ADDENDUM NO. 2

CITY LAKE AQUATIC CENTER RENOVATION: SITE AMENITIES

RFP 2024-019

CITY LAKE PARK
2023-2024 RENOVATIONS
BUILDING & SITE IMPROVEMENTS PACKAGE (Bid #2024-019)
MESQUITE, TEXAS

A1.0

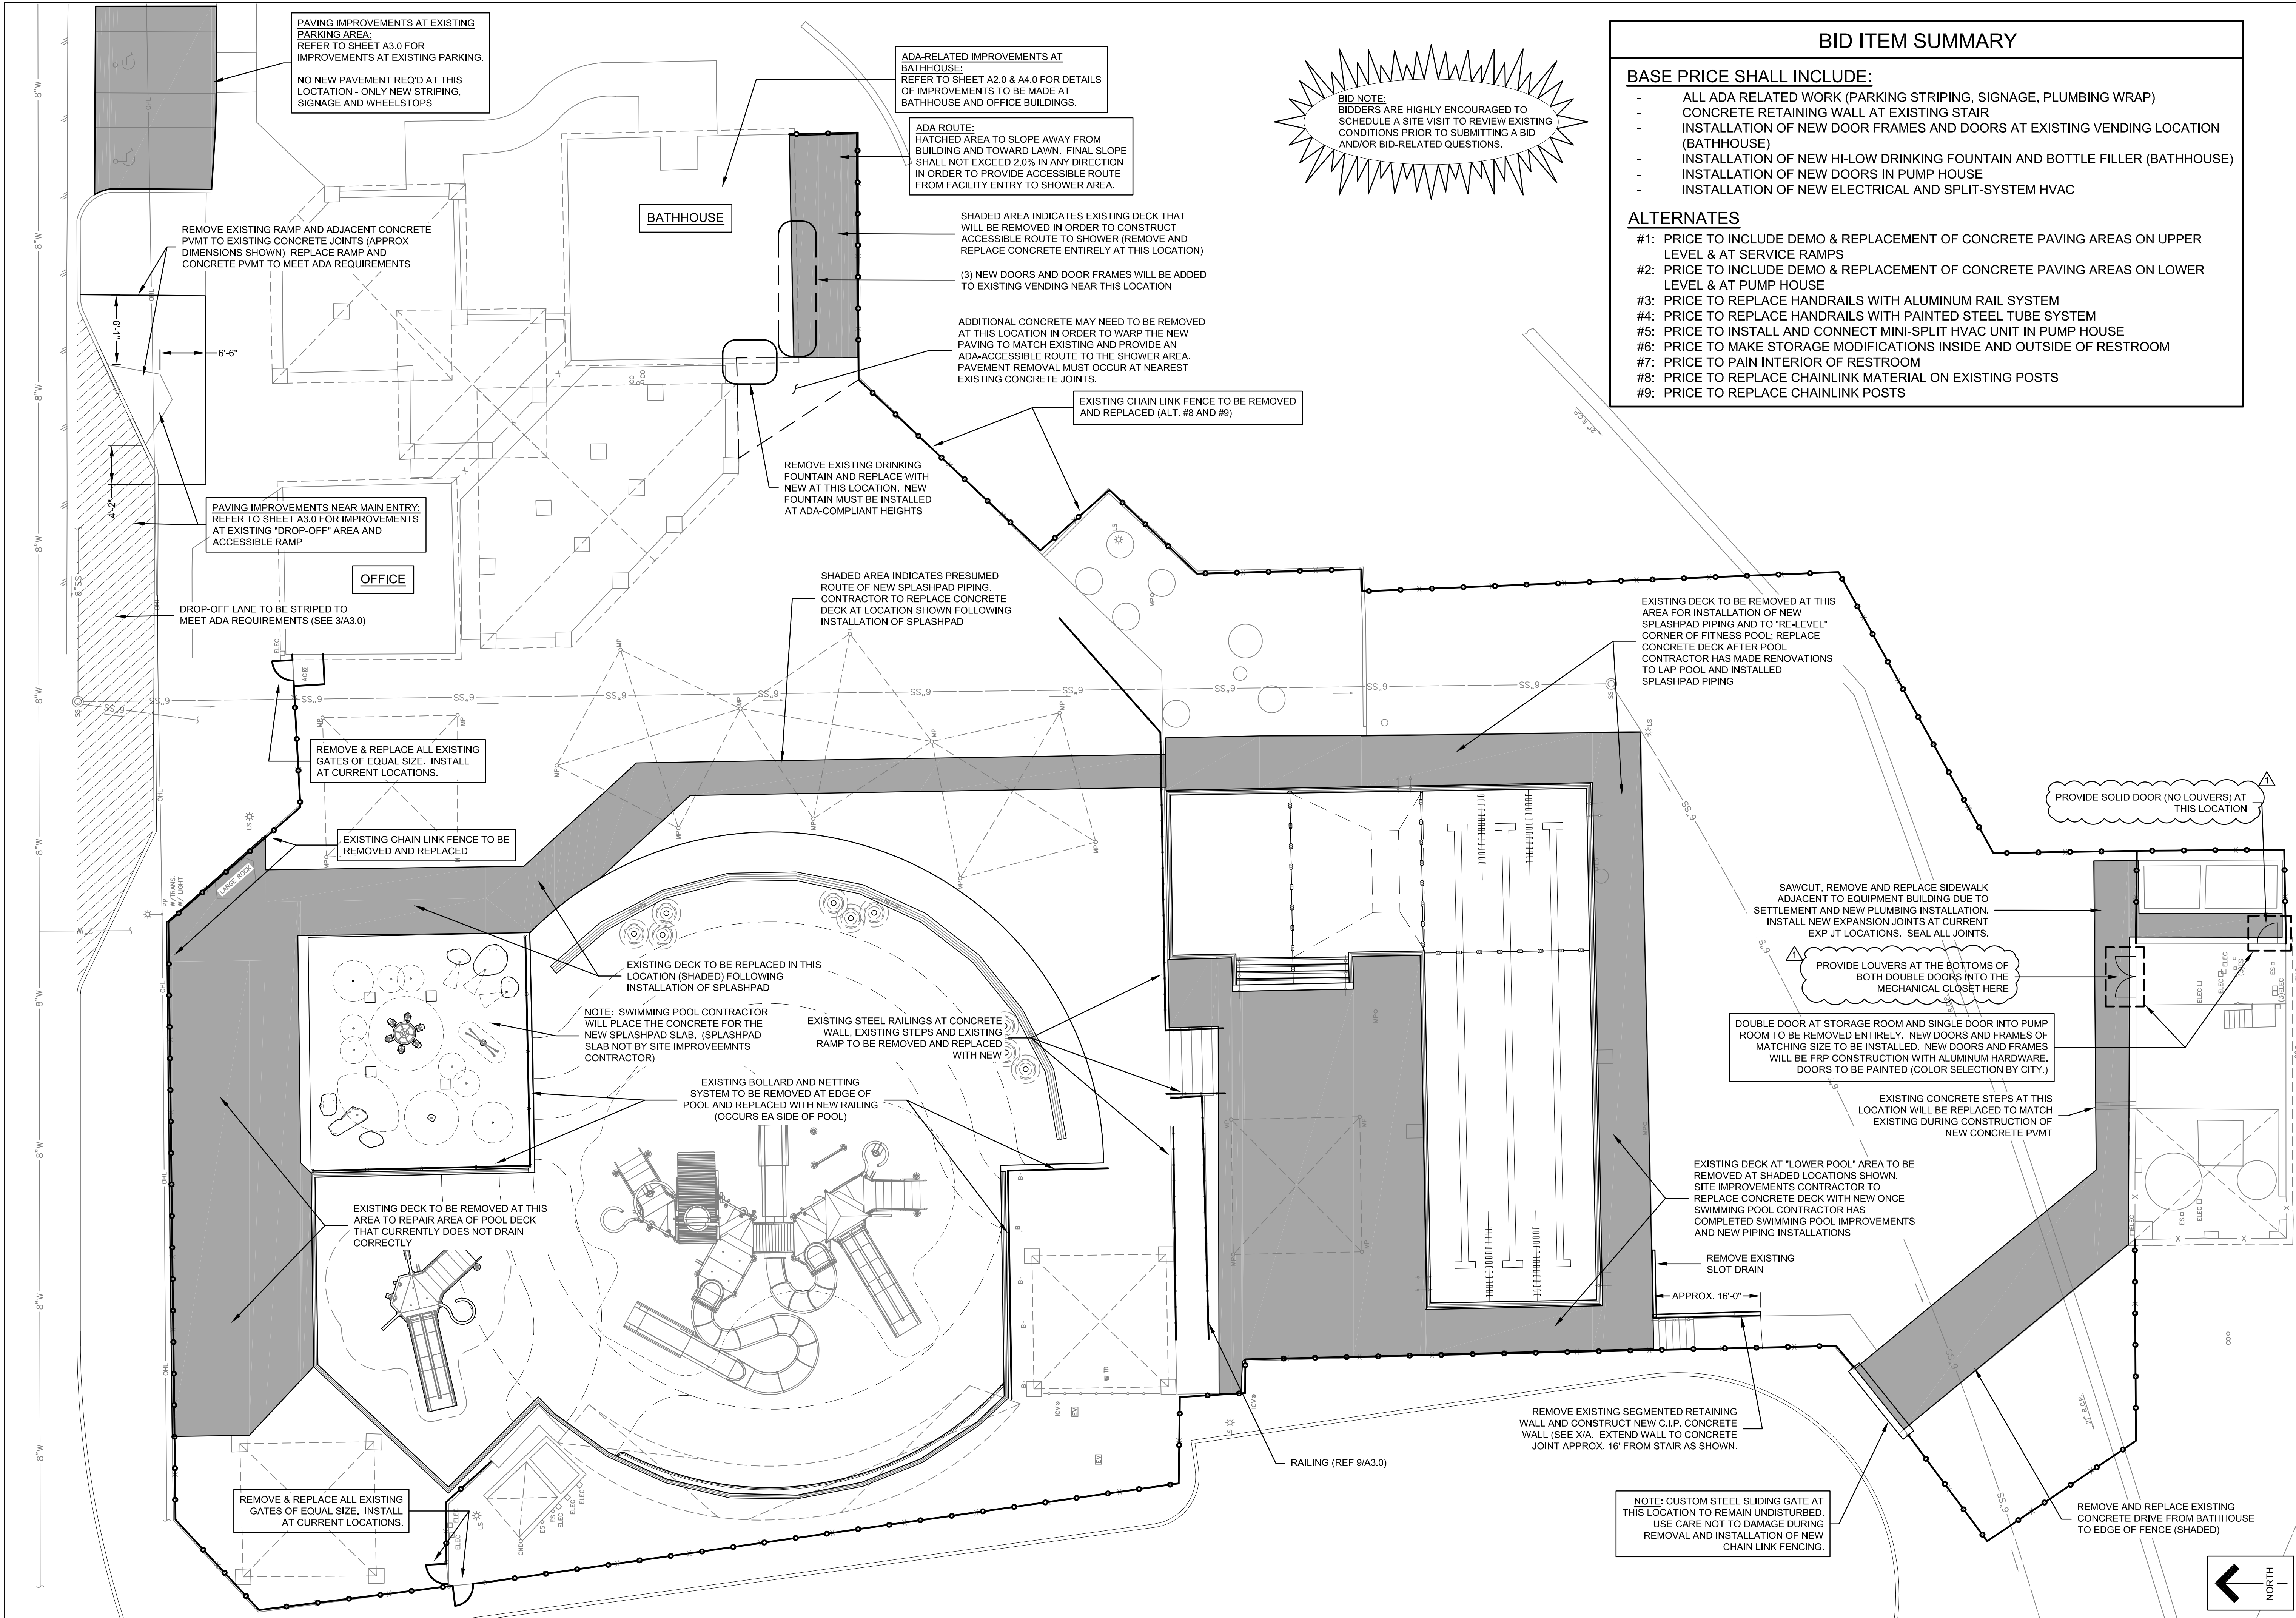
- 1) **Sheet A1.0 – Doors at Pool Equipment Building:** When replacing the new single door into the pump area of the equipment room (located on the east wall of the building), the door shall be furnished with no louvers. When replacing the new double doors into the controls closet (located on the north side of the building), each door shall be furnished with louvers. Refer to notes added to sheet A1.0.

Sheet No.: A2.0

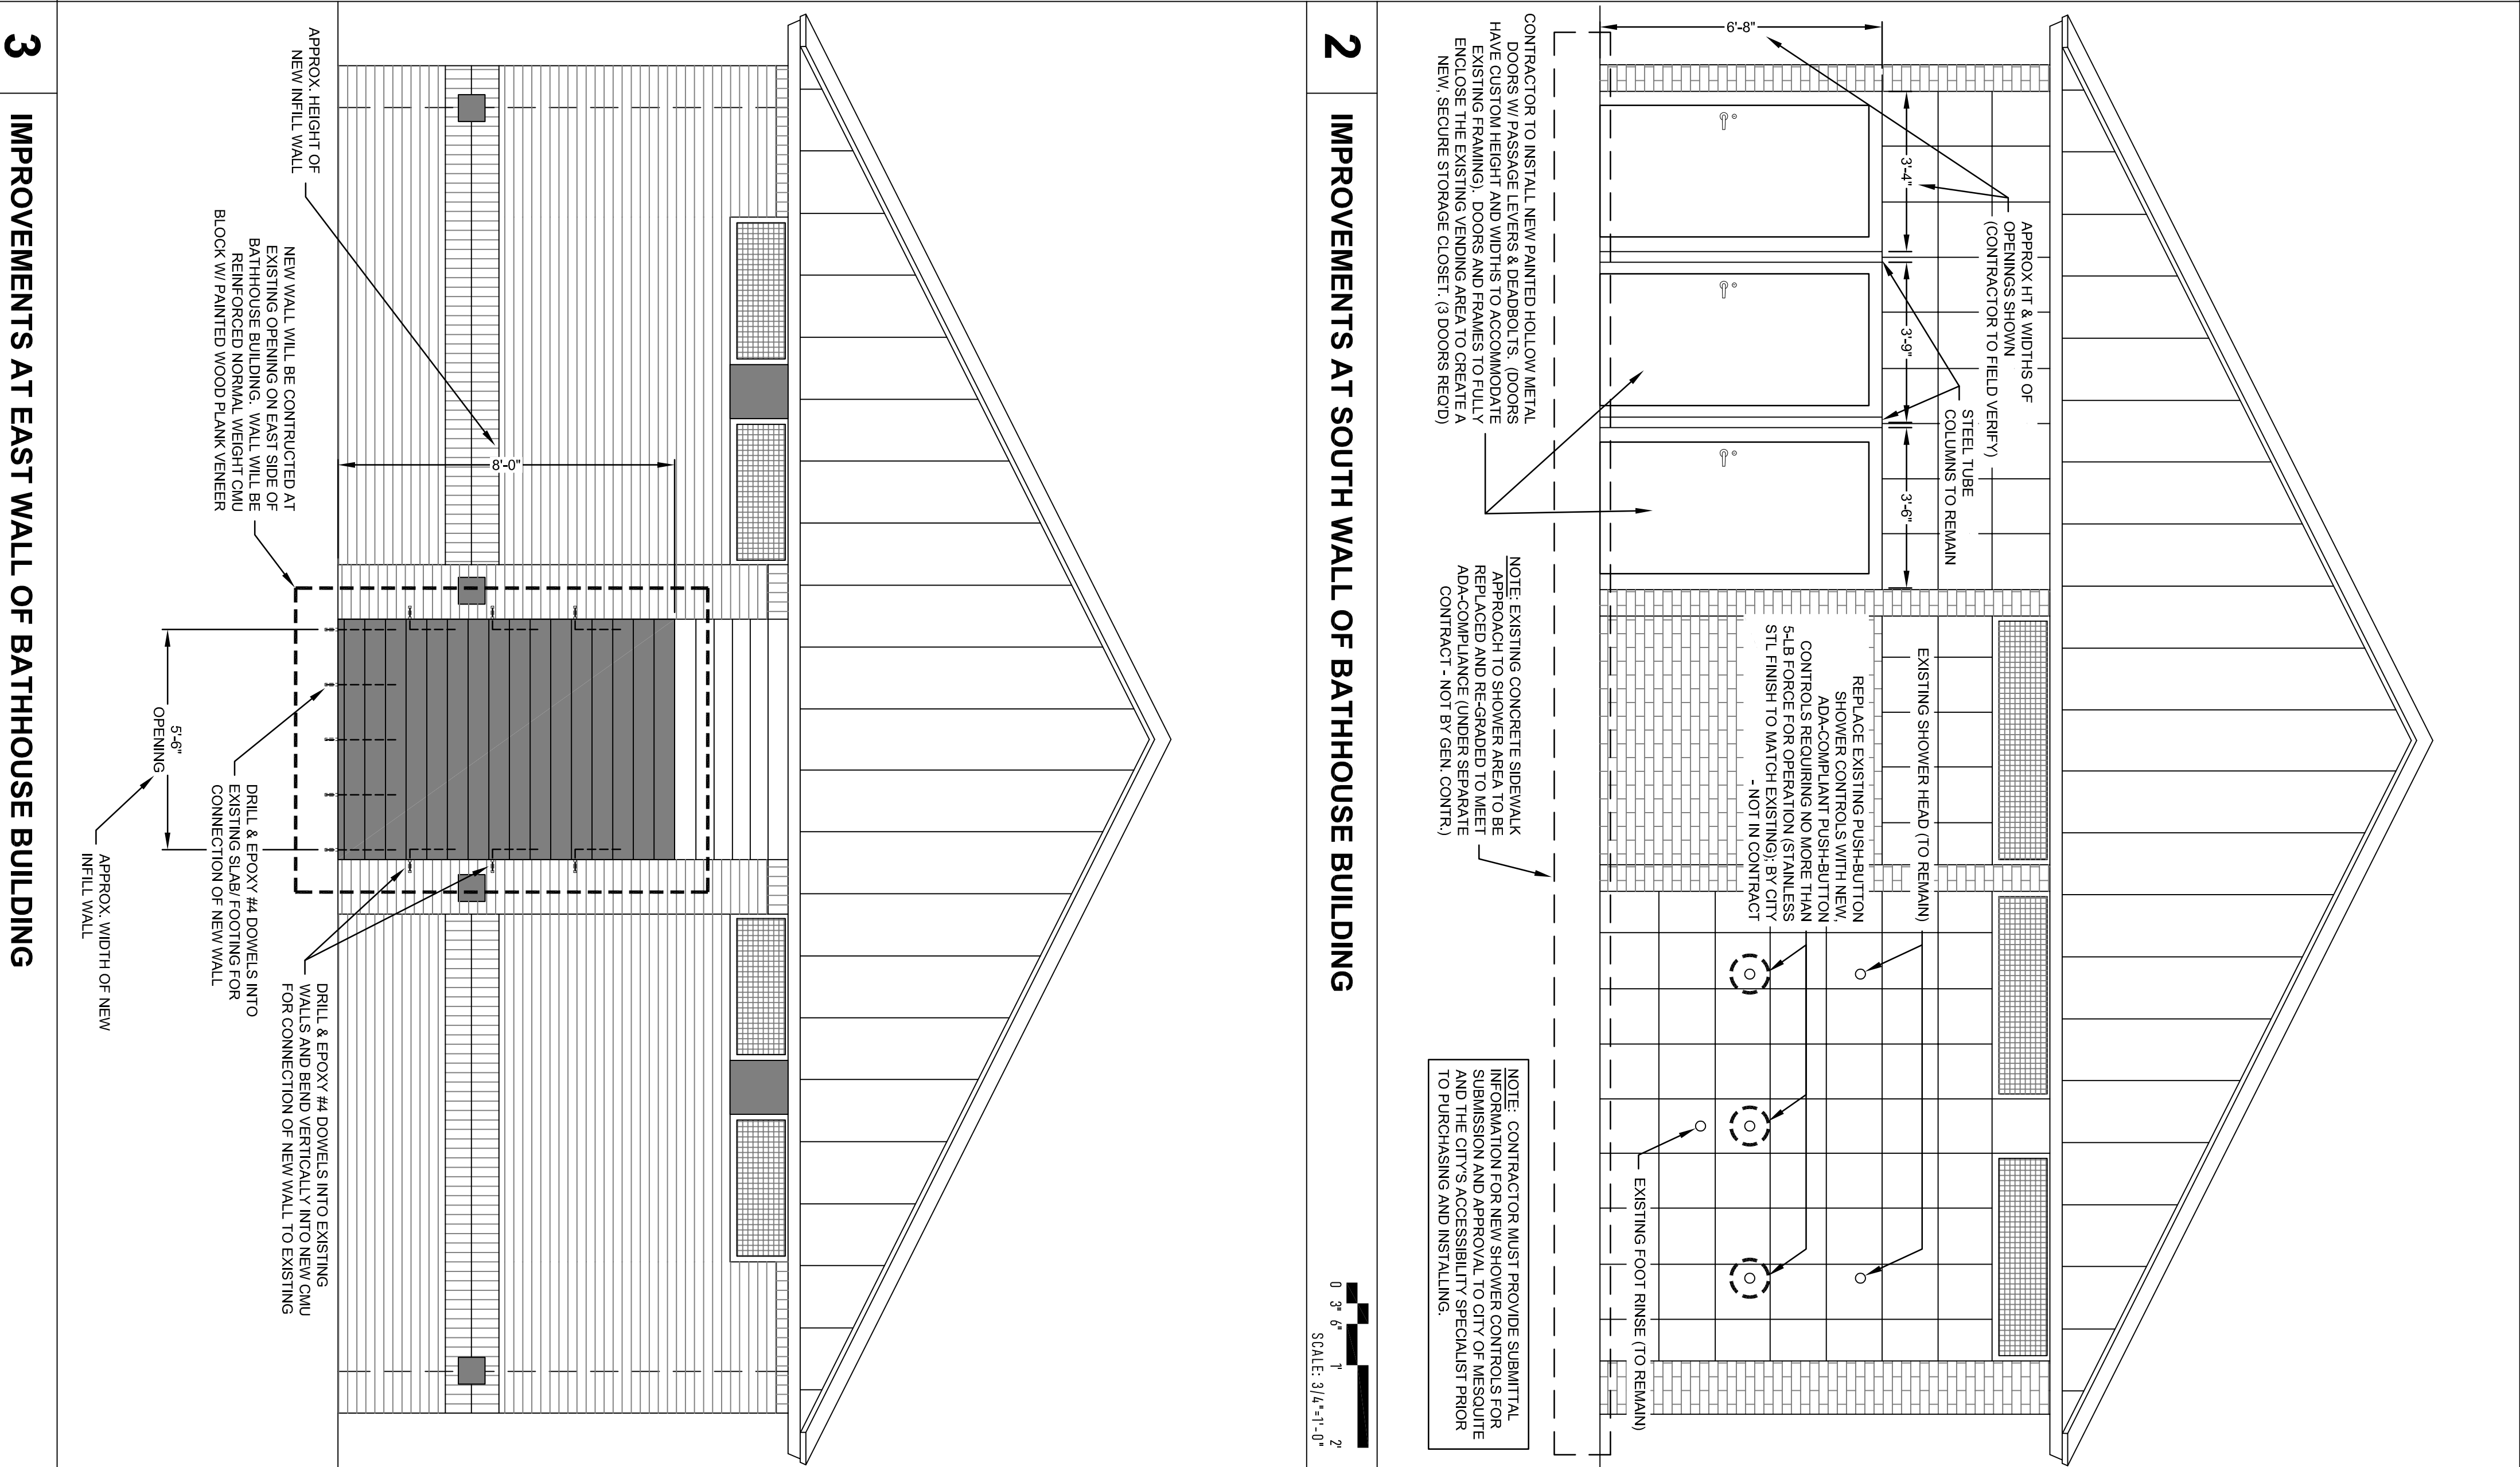
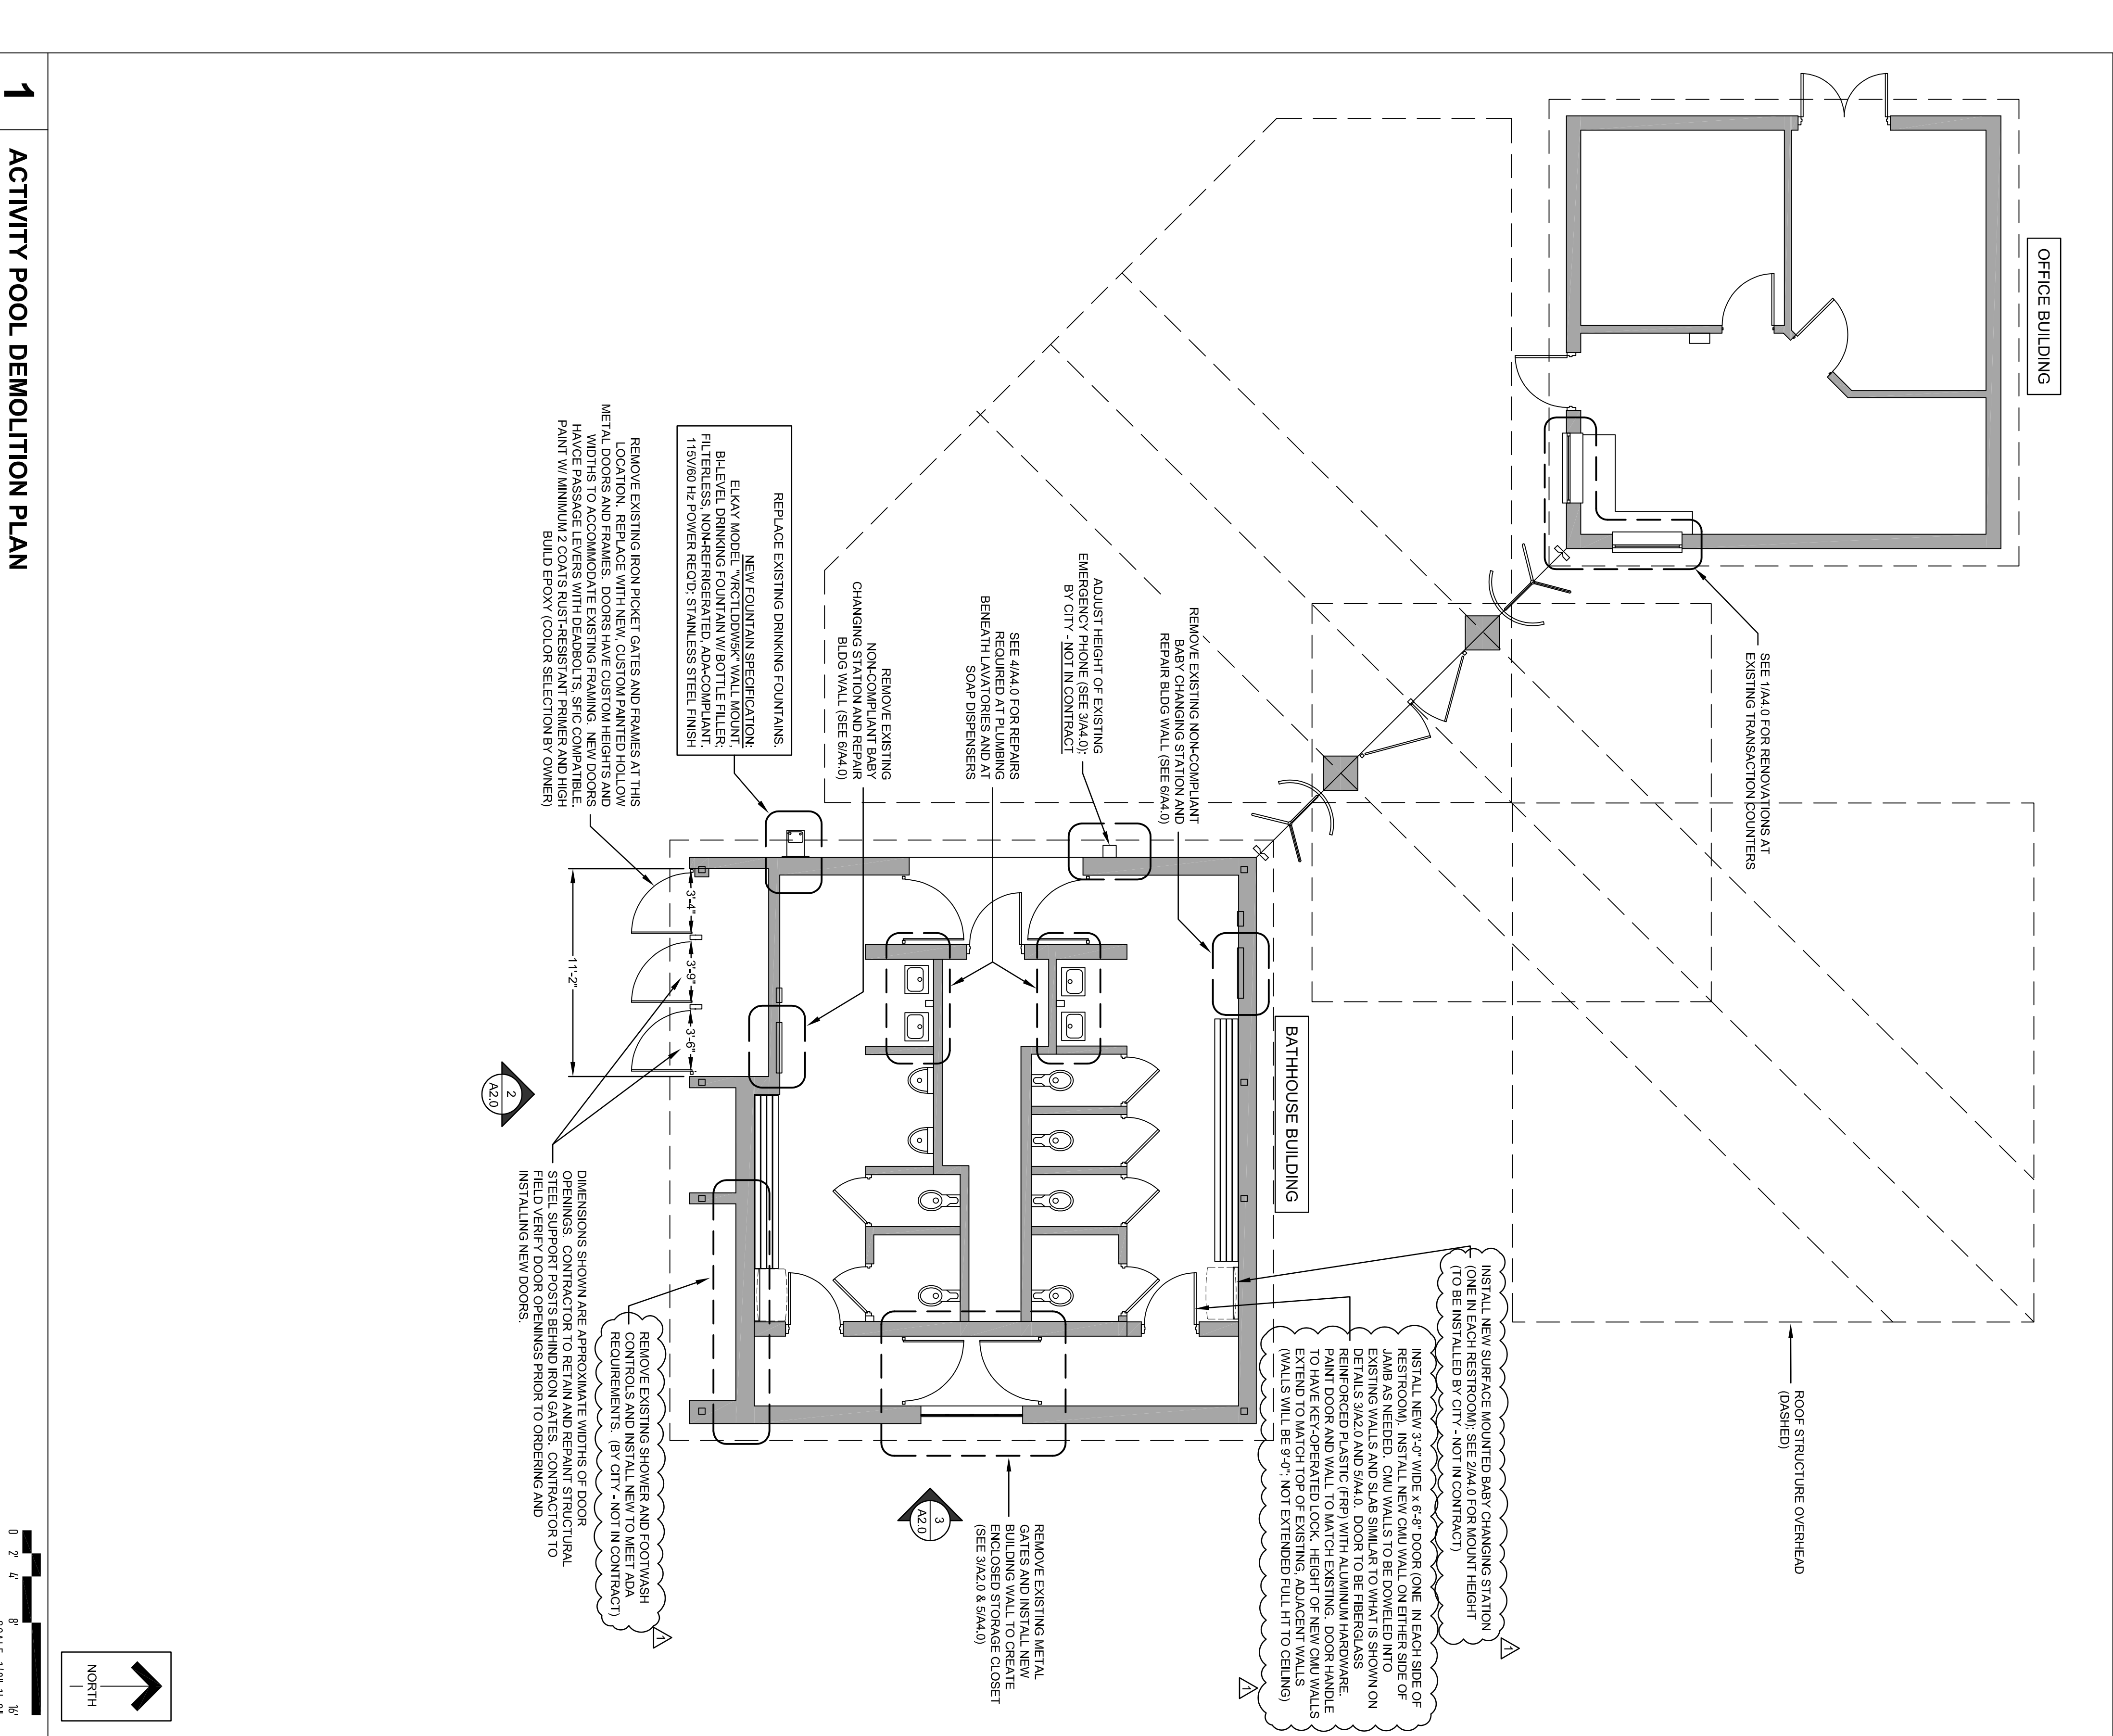
- 2) **Sheet A2.0 – New Closet on East Side of Building:** Please note that the new walls constructed to create a storage closet on the east side of the locker room building have been oriented in the north-south direction to provide a larger closet space. The intent is for the new CMU wall to align with the existing CMU wall on the east side of the last toilet stall in each restroom (as shown on A2.0). Please refer to plan changes on sheet A2.0.

- 3) **Sheet A2.0 and A4.0 – Baby Changing Station:** The baby changing stations for both restrooms will now be furnished and installed by the City of Mesquite and are no longer part of the contract. Please remove equipment and installation of baby-changing stations from the bid.
